UNITED STATES PATENT AND TRADEMARK OFFICE

APPLICATION NO.	FILING DATE	FIRST NAMED INVENTOR	ATTORNEY DOCKET NO.	CONFIRMATION NO.								
10/646,545	08/21/2003	Douglas S. Hine	P-11138.00	9714								
7590 Elisabeth L. Belden Medronic, Inc. 7000 Central Ave., N.E. Mailstop B408 Minneapolis, MN 55432		10/08/2008	<table border="1"><tr><td colspan="2">EXAMINER</td></tr><tr><td colspan="2">ALTER, ALYSSA MARGO</td></tr><tr><td>ART UNIT</td><td>PAPER NUMBER</td></tr><tr><td>3762</td><td></td></tr></table>		EXAMINER		ALTER, ALYSSA MARGO		ART UNIT	PAPER NUMBER	3762	
EXAMINER												
ALTER, ALYSSA MARGO												
ART UNIT	PAPER NUMBER											
3762												
			<table border="1"><tr><td>MAIL DATE</td><td>DELIVERY MODE</td></tr><tr><td>10/08/2008</td><td>PAPER</td></tr></table>	MAIL DATE	DELIVERY MODE	10/08/2008	PAPER					
MAIL DATE	DELIVERY MODE											
10/08/2008	PAPER

Office Action Summary	Application No.		Applicant(s)	
	10/646,545		HINE ET AL.	
	Examiner		Art Unit	
	ALYSSA M. ALTER		3762

DETAILED ACTION

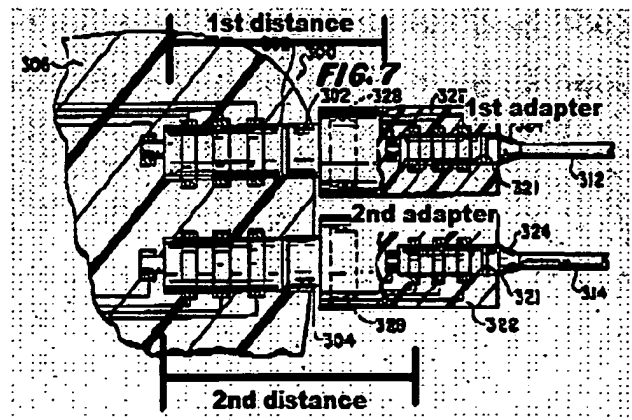
1. Claims 1, 3-4, 6 and 11-13 stand rejected under 35 U.S.C. 102(b) as being anticipated by Pohndorf et al. (US 4,628,934). Pohndorf et al. discloses a pacemaker with a connector bore for electrically and mechanically connecting the implantable medical device (IMD) with two adapters and multi-electrode leads as displayed in figures 6 and 7. The adapters upsize the leads prior to the insertion into the connector bore within the IMD. The array of lead connector elements are displayed in figure 2 as "sleeves 151 and 152 (in contact with rings 141 and 142) (col. 7, lines 63-64)". The sleeves are connected to electrodes, with a conductor for each electrode. The two adaptors, which the examiner considers to be a plurality of adaptors, have an inner lumen for engaging the sleeves of the lead with rings to create an electrical and mechanical connection. In addition, the adaptors have an external surface used for engagement with the electrical bore. This engagement surface has two contact zones, the pin as the first zone and sleeves of the lead as the second zone, which connects within the IMD with the socket and rings, respectively.

As to claims 1 and 11, the examiner has included a replication of figure 7 to display the first and second distances. The examiner considers the first distance is to the first contact zone and the second distance is to the second contact zone. Therefore the first distance is not equal to the second distance.
